Memorandum
Department of Planning and Development
Historic Preservation Office

To: Chair Morrisette and Members of the Planning Board
From: Deborah Andrews, Historic Preservation Program Manager
Date: October 4, 2012
Re: Proposed Hotel at Northeast Corner of Fore and Union Streets -
Historic Preservation Board's Analysis of Historic Context,
Comments on Preliminary Design Proposal

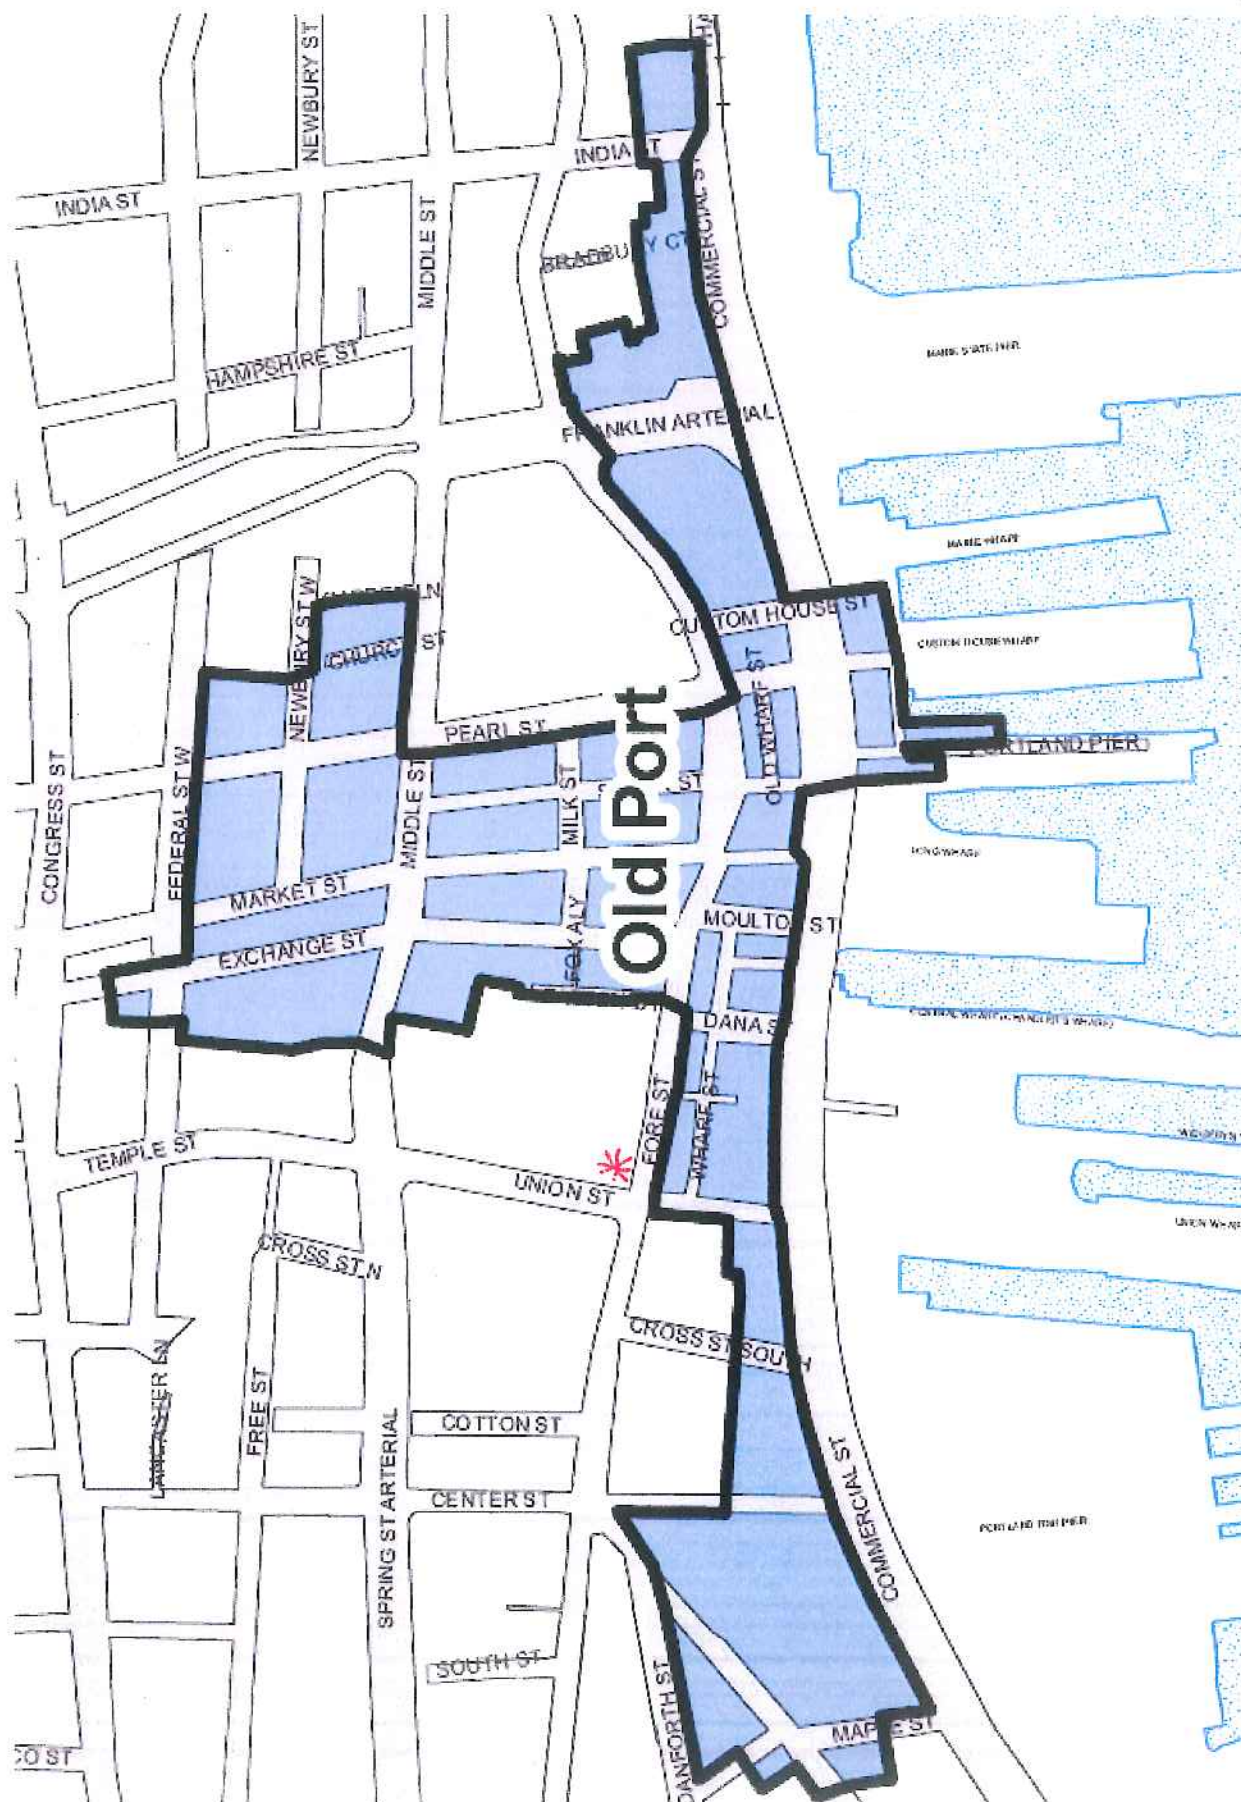
Much of the Board’s discussion centered on the question of how compatibility can best be achieved in this homogeneous historic context given the fact that the proposed building--by virtue of its large footprint and the height allowed by zoning—is fundamentally uncharacteristic of the size and scale of buildings within the district. The project architect argued that the way to best respect the historic context was to provide a contrast or counterpoint to it. He also argued that if the design were to echo some of the architectural characteristics shared by its historic neighbors (a regular window pattern, for example), the hotel building would appear bulky and ponderous. Some members of the Board were generally satisfied with this approach, identifying a number of other design and massing characteristics that served to tie the hotel to its historic context. Other members felt that more could be done to reinforce some of the strongest architectural characteristics of the context. For example, they pointed out that the irregular window pattern of the hotel’s upper floors belied its very regular structural organization and building program on the inside. They argued that one of the key characteristics of the historic buildings on Fore Street was that their structural organization was reflected on the exterior. By adjusting the fenestration on the upper floors of the hotel—even slightly—to reflect a series of organizational “bays”, the building would better reflect its actual organization and exhibit some of the vertical divisions that are characteristic of the existing Fore Street streetwall.

Regarding the proposed massing and vertical organization of the building, members appeared to be generally satisfied, especially given the presence of Two Portland Square immediately west of the intersection. The height and massing relationship of the hotel to its neighbors would not be unlike that of Two Portland Square to its neighbors across the street. They also noted that the series of stepbacks at Two Portland Square helps to mitigate its overall height.

- The Board was generally supportive of the treatment of the ground floor level. They noted that the proposed height of the ground floor (11’4”) was consistent with the base heights of the historic buildings on Fore and helps create a human scale at the street level. The introduction of sun screens over the ground floor also reinforces this human scale and the presence of regularly-spaced heavy granite columns serves as a reference to the granite piers that define the storefronts on Fore.

- Board members supported the limestone-based material proposed for the exterior as it exhibits a natural, organic quality that will patina over time. They also noted that the pattern and scale of the panels establishes a fairly fine-grained texture, also characteristic of the area. Board members indicated that they would have concerns if the exterior were clad in a “slicker”, more monolithic material. The Board also indicated that the selection of granite for the ground floor piers was an appropriate choice. Finally, Board members stressed that any “value engineering” involving substitutions in exterior materials should be avoided to ensure that the new building is commensurate in quality with the architecture with that defines the Old Port.

- The general proportions of the individual upper floor windows were seen as compatible with those of its historic context. The organization of the windows, which creates something of a “digitized” façade, was a point of debate, however. (See above discussion.)

- Board members noted that the rooftop mechanical screen adds to the overall perceived height of the building and urged that it be lowered in height to the extent possible and de-emphasized.

- Board members stressed the importance of providing architectural interest to the rear or north elevation of the building. Given the presence of the CMP transfer station, it is likely that this façade will be highly visible for the foreseeable future and should not be treated as a strictly secondary façade.

- Board members stressed the importance of the eastern corner of the hotel, particularly at the ground floor level, where the corner of the hotel will project beyond the face of the garage next door. Glazing this corner and providing an entrance in this location was endorsed. Board members also noted that the sunscreen on this facade will extend beyond the face the adjacent garage. This design detail should be given careful consideration.
